COMMENTS RECEIVED AFTER CUTOFF FOR 9/1
MEETING AND BEFORE CUTOFF FOR 9/15
MEETING.

From: Larry Brandhorst <lbrandhorst@thearchitectsalliance.com>
Sent: Tuesday, September 1, 2020 7:55 AM
To: Sean Mullin <SMullin@losgatosca.gov>
Cc: Joel Paulson <jpaulson@losgatosca.gov>; Sally Zarnowitz <SZarnowitz@losgatosca.gov>; Robert Schultz <RSchultz@losgatosca.gov>
Subject: RE: 101 Broadway, Los Gatos

Subject: 101 Broadway | Fwd: Section 9.5.20 for 93

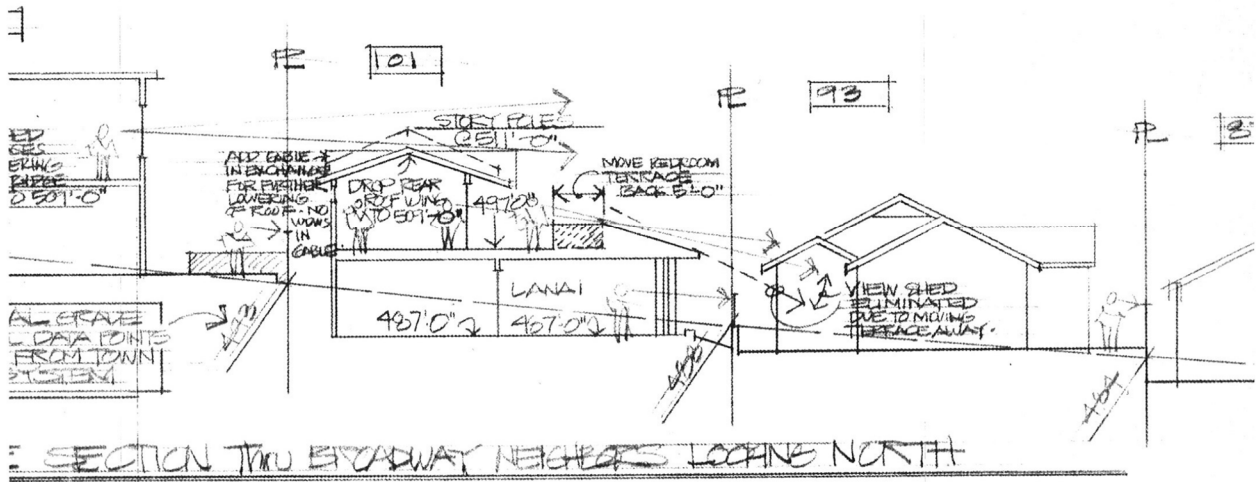
The Architect for the 101 Broadway House contacted me yesterday and tried to tell me the 93 Broadway view was shielded by the existing fence.

He proceeded to send me the attached drawing section showing the existing wall/fence hiding the view. I proceeded to send him the other attached photo showing the view to 93 Broadway with elevations from the Civil drawings.

As you can see the main floor elevation of 101 Broadway is higher than the block wall between our properties; almost level with the lower roof line of 93 Broadway.

I also mentioned to him my concern about the **storm drainage** over the walls etc. onto 93 Broadway. He said that wouldn't happen because there wasn't that much difference in grade level between the two houses.

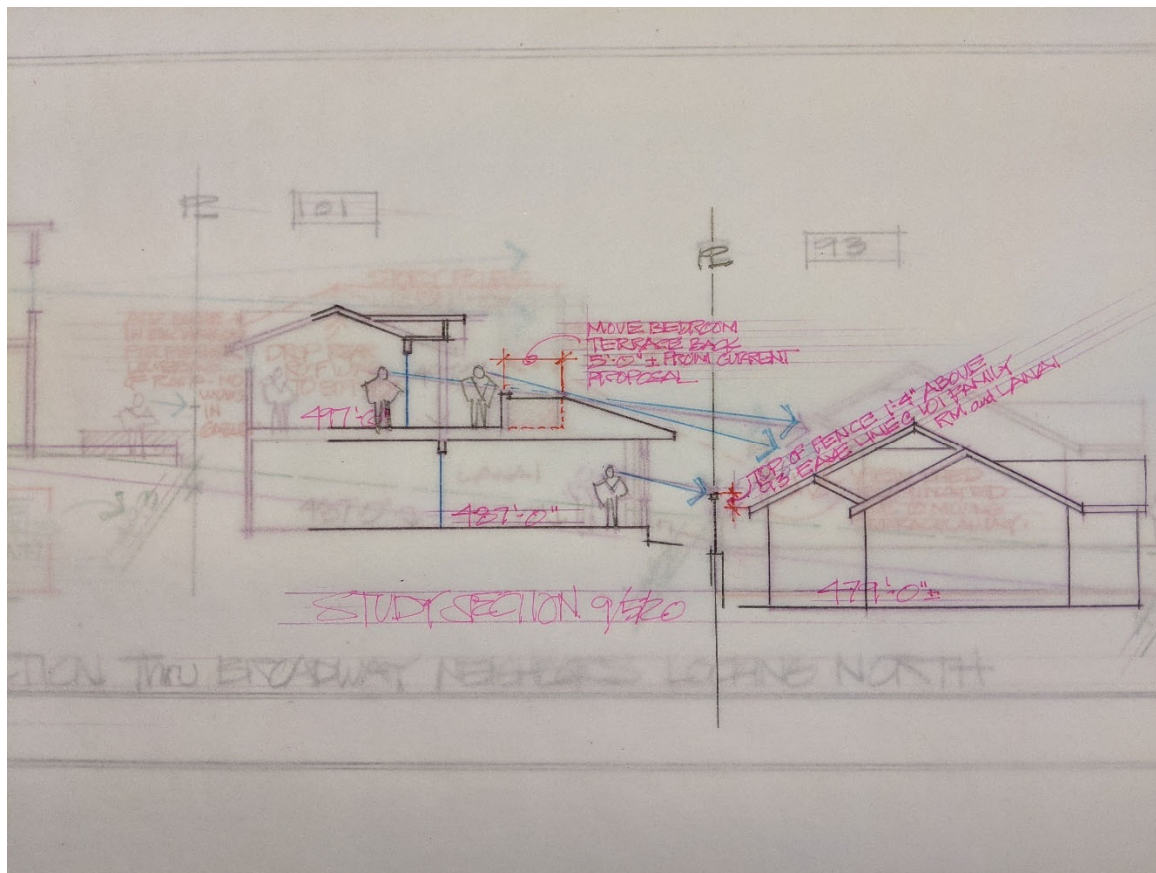
Hi Sean - Mark and I spoke with Larry Brandhorst earlier today to discuss the attached modifications to 101 Broadway.

Move upper Terrace farther away from 93 by 5 feet.

We will build a fence between the properties to a height of 1.33' above the level of 93's roof eave line.

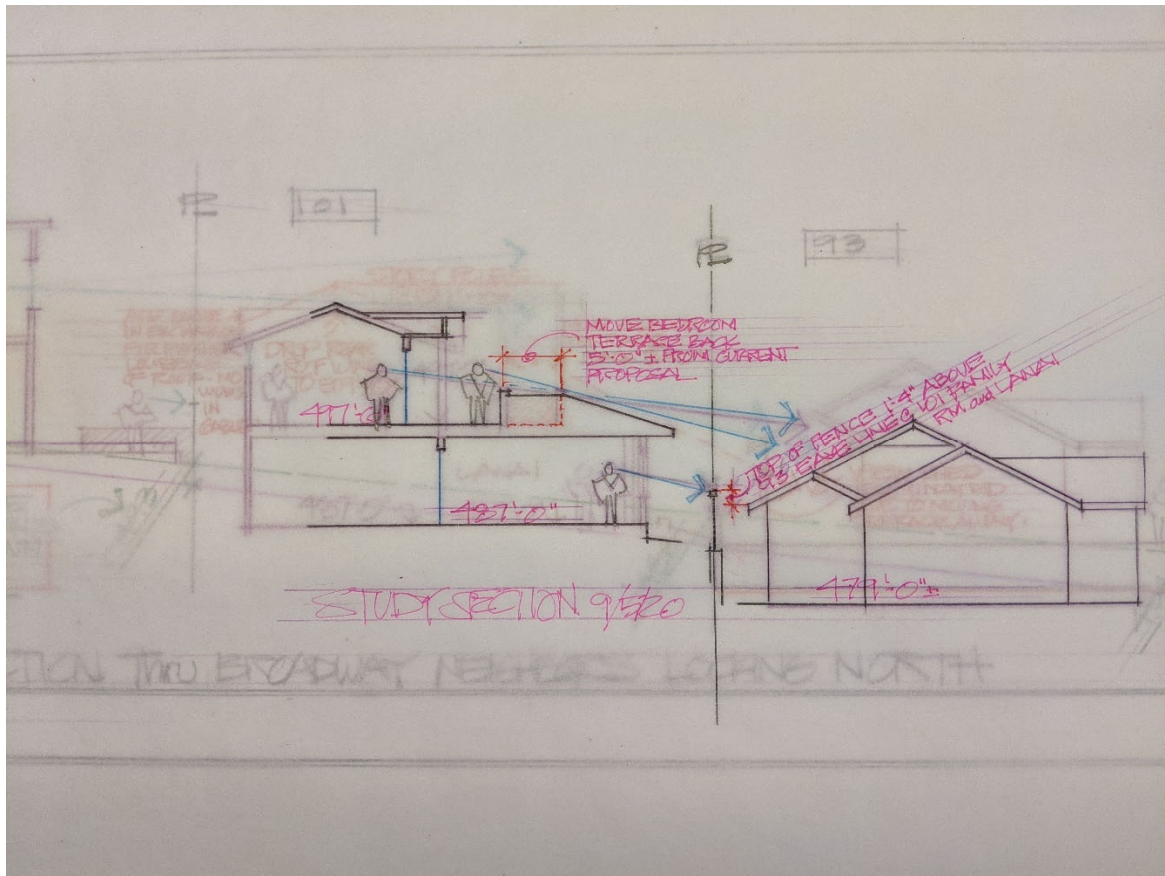
After conversation with Mark DeMattei and Jay Plett and review of their corrected elevation section at the back of 101 & 93 Broadway, it was agreed that they would add an acceptable screening fence to at least 1.33 feet above the level of 93 Broadway's West eave line, between the properties as shown in Jay Plett's attached drawing.

They also agreed to move the east edge of the upper level M. Bedroom Terrace back 5 feet from their original drawing location (at approx. 17 ft. from the property line), per attached drawing.

We do still have some concern about the storm drainage runoff between the two properties and onto 93 Broadway, because of the height difference; but I assume this will be addressed between the Civil Engineer and approved by the Town of Los Gatos.

The fence would be along the property line, possibly on top of the existing block/concrete walls and would include removal of the existing short fence on the west side of the existing wall at 93's patio area.

The fence would be required, at a minimum, along 93's patio area and the second level terrace area; not less than 40 ft. in length.
